Service Bulletin TM 315-34

GROB G 103 A TWIN II ACRO

Inspection and, if necessary, exchange of the elevator push-rod III (103A-4244) or the elevator push-rod IV (103A-4694) respectively.

Repair Instructions No. 315-34 for Service Bulletin TM 315-34

ELEVATOR PUSH-ROD IV 103A - 4694 HOLE DIA.6mm

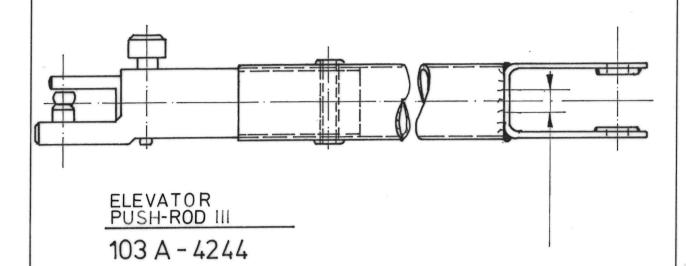
- 1. Remove rudder
- Remove elevator push-rod (elevator push-rod III 103A-4244 or elevator push-rod IV 103A-4694 respectively)
- 3. Inspect the elevator push-rod for water of condensation and corrosion as follows:
 - a) The elevator push-rod must be drilled on the lower fork head end according to the drawing (hole dia. 6 mm)
 - b) Check whether water of condensation comes out. affirmative, the elevator push-rod must be replaced by a new one.
 - c) In the negative, the tube must be knocked up to 100 mm after the lower fork head end (e.g. with the wooden handle of a screw driver). If by doing so, rust is falling out of the hole, the elevator push-rod must be replaced by a new one.
- 4. In case a new elevator push-rod is needed, the old one must be returned to the manufacturer.

5. In case the existing elevator push-rod can be used, it must be treated inside with the above mentioned corrosion preventative before installation. The hole remains open.
